This document is generated in response to the queries asked in the e-mail from Compliance Certification Services titled "Kyocera Wireless Corp, FCC ID: OVFKWC-KX16, Assessment NO.: AN05T5286, Notice#1". The queries asked in the e-mail received by Lin Lu on 14th of November 2005 are listed below followed by the response the questions.

Subject: Kyocera Wireless Corp, FCC ID: OVFKWC-KX16, Assessment NO.: AN05T5286, Notice#1

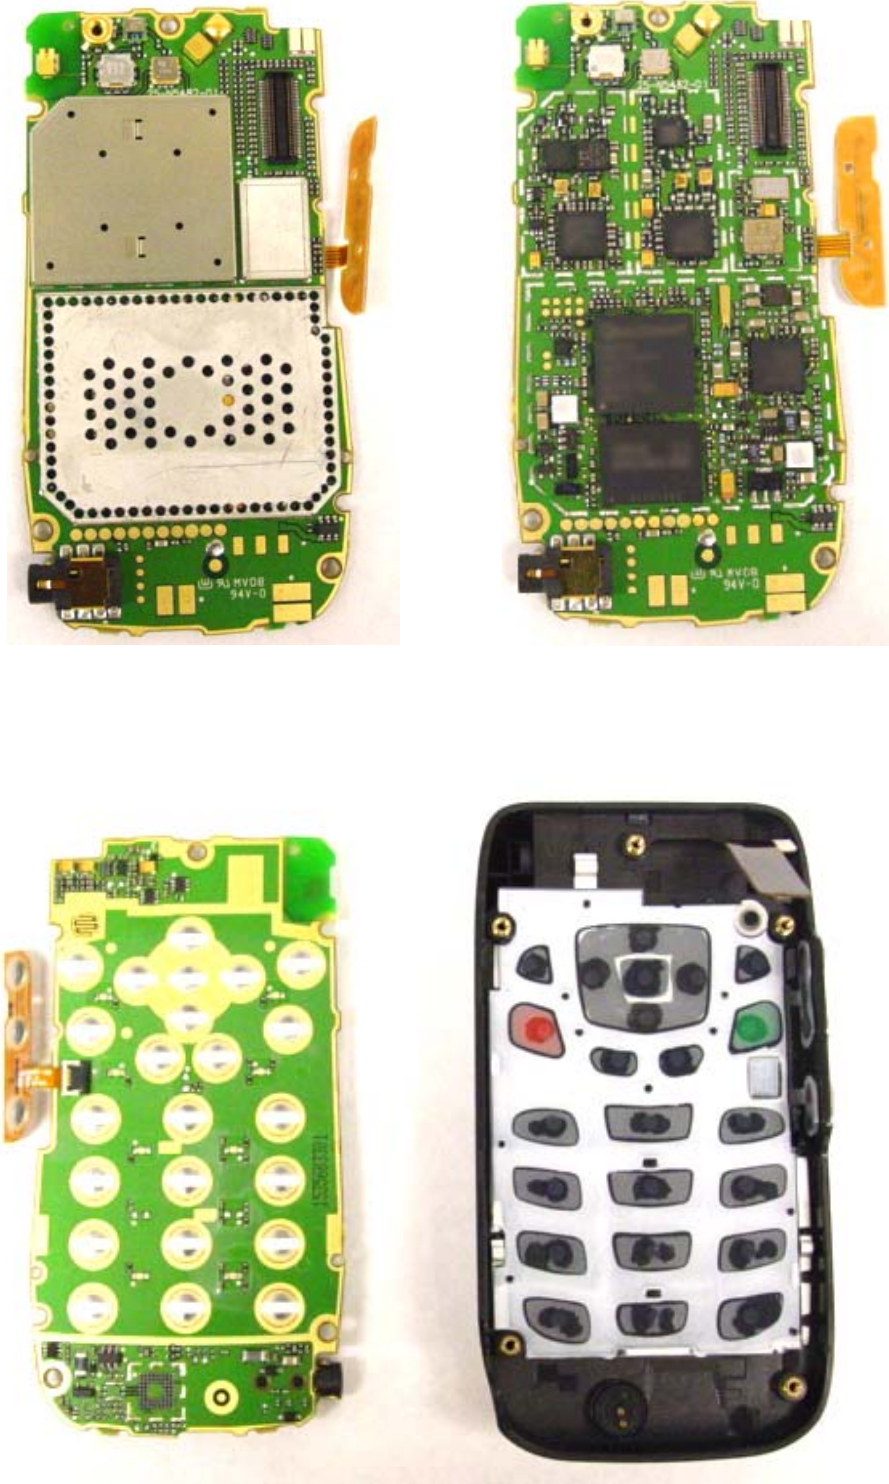
Question #1: As indicated in the Class II permissive change cover letter, the major change is the alternate PCB manufacturer (Unitech). However, only SAR evaluation is performed but not Part 22/24 related tests. Please provide your justification why changing the PCB manufacturer has effects on the SAR evaluation but not the Radio characteristic.

The Printed Circuit Board provided by the alternate manufacturer has the same electrical characteristic as that provided by the primary manufacturer, i.e., same number of layers, same amount of copper and same permittivity and permeability of FR4. Therefore we do not expect any change on the electrical performance of KX16 by using the alternate PCB. In order to ensure the KX16 in compliance with FCC requirements, the SAR measurement was conducted. Due to the measurement uncertainty, the SAR value in worst case was higher than the value initially submitted. Therefore we are filling the application of Class II permissive change.
